**ENCORE 65**  
 BD. # 98850171 (10/3/83)  
 BD. # 98850172 (8/16/84)

ENCORE 65

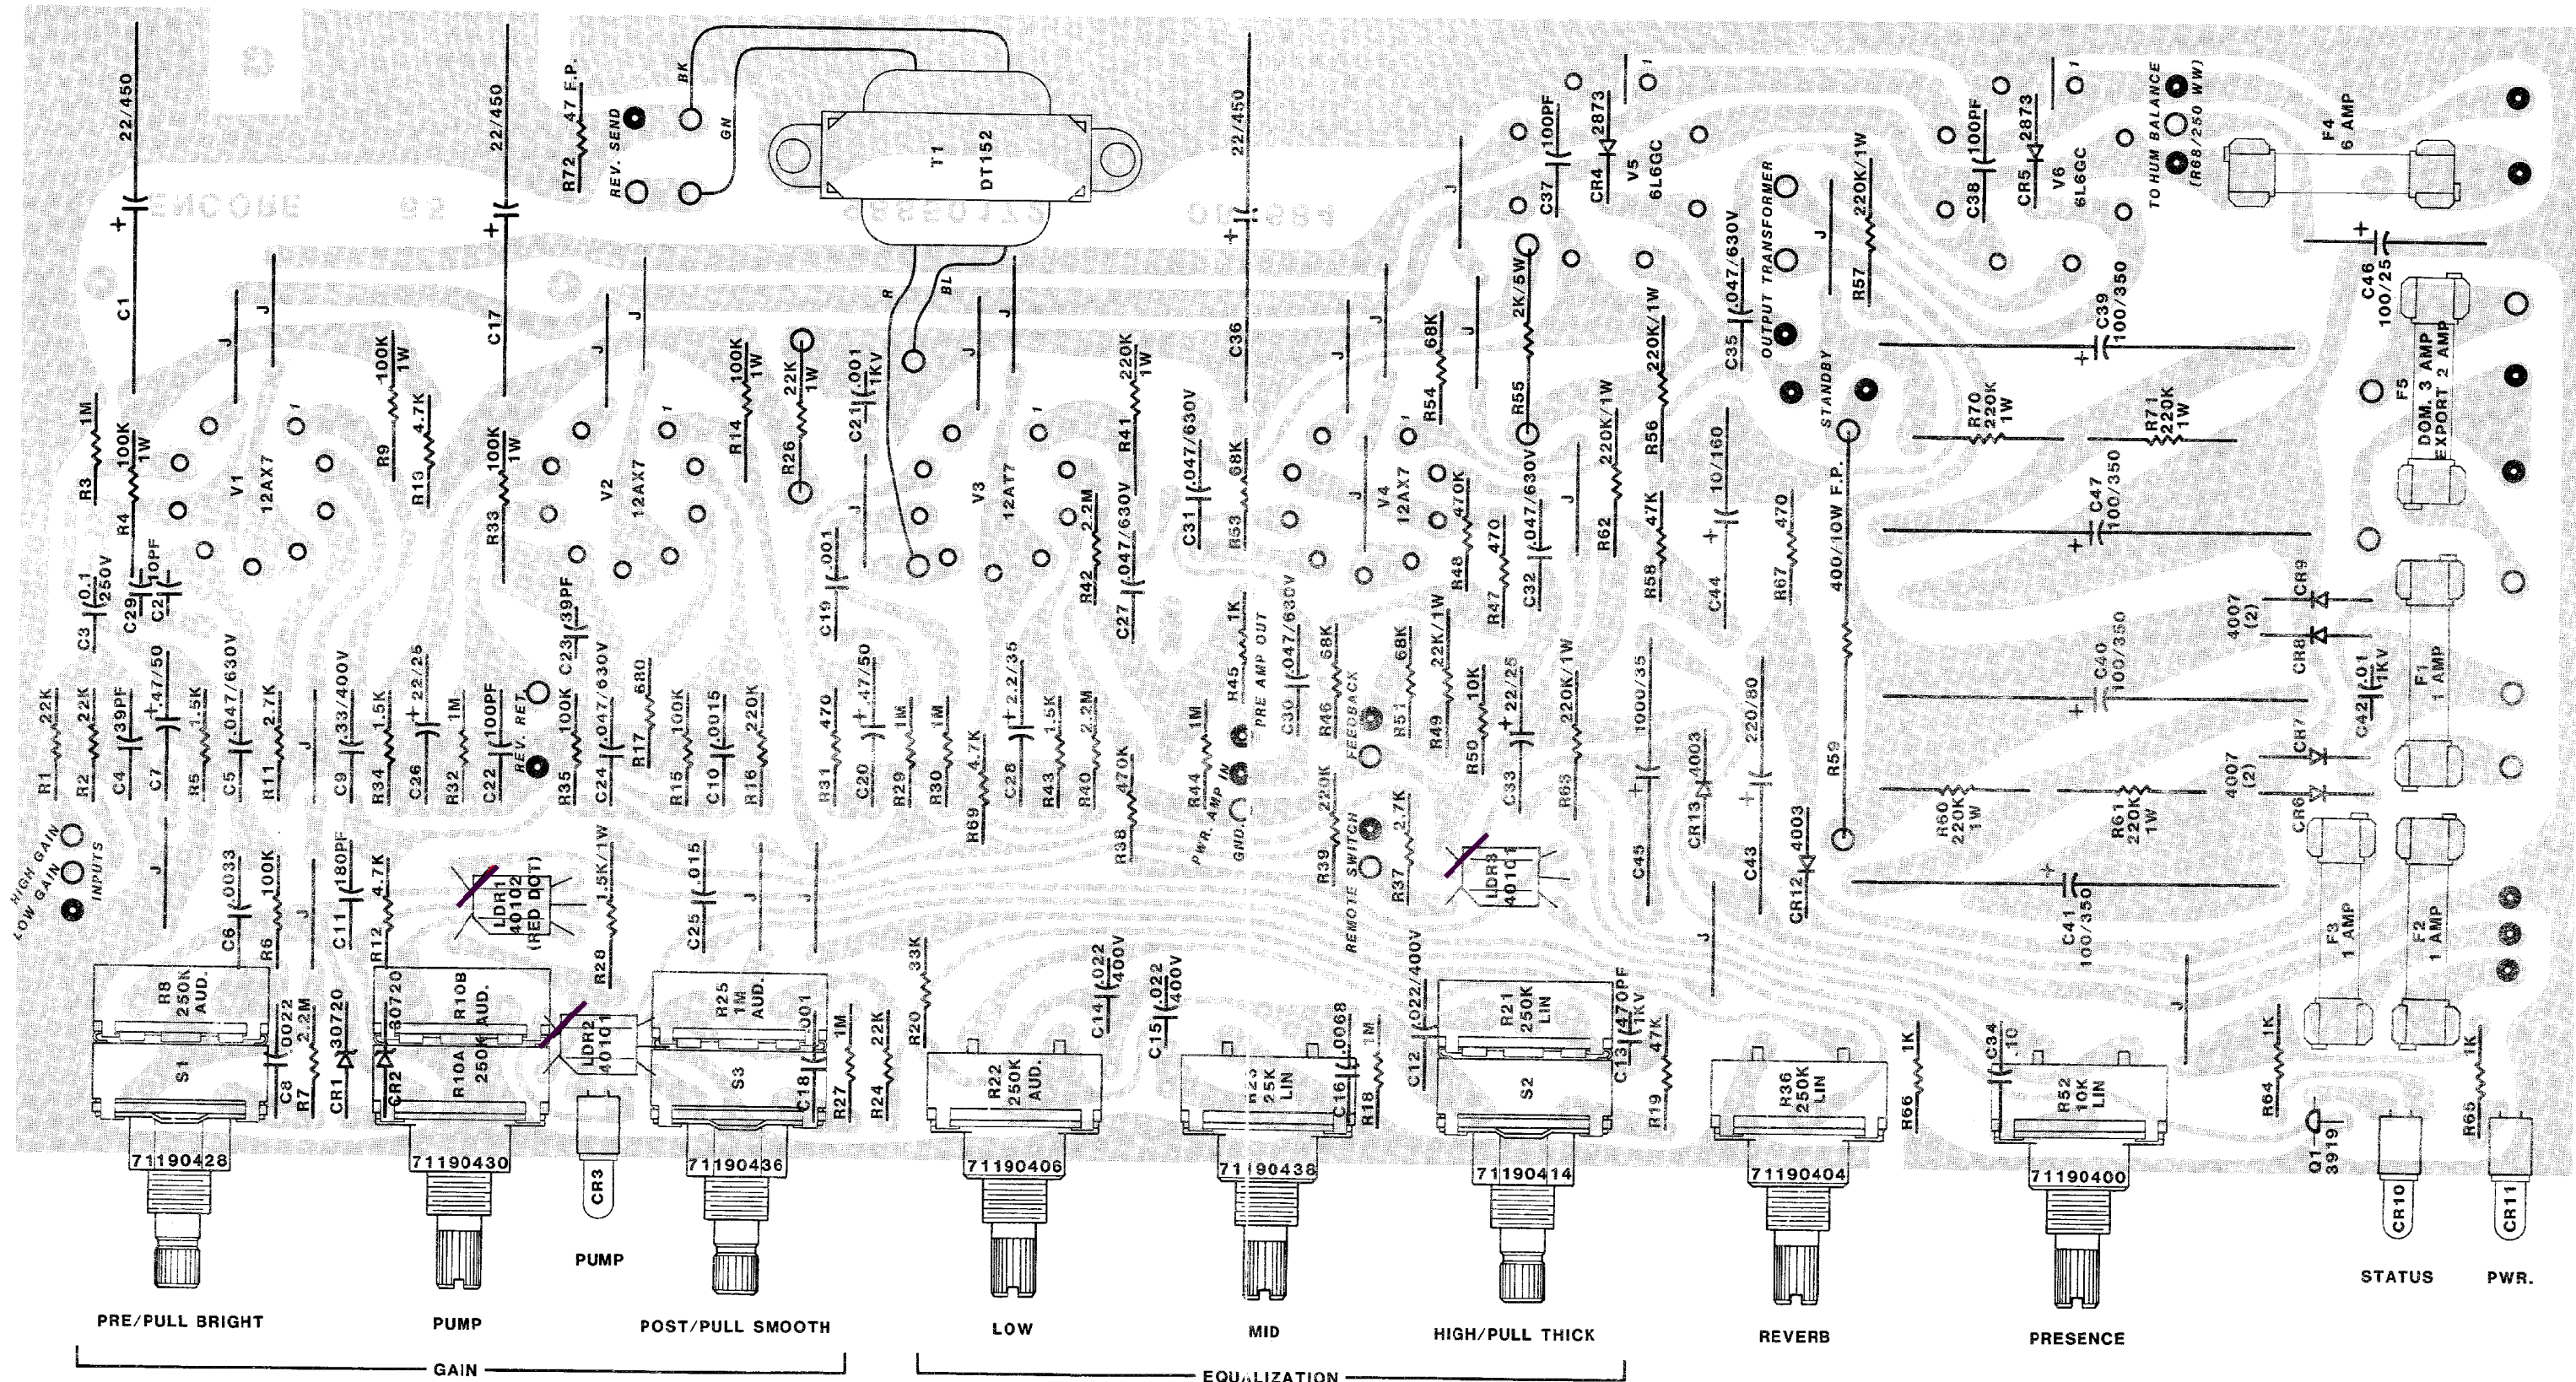
\*Please Note: The LDR's are drawn incorrectly on the layout. The flats should be positioned away from the pots as per the added lines. The schematic itself is correct.
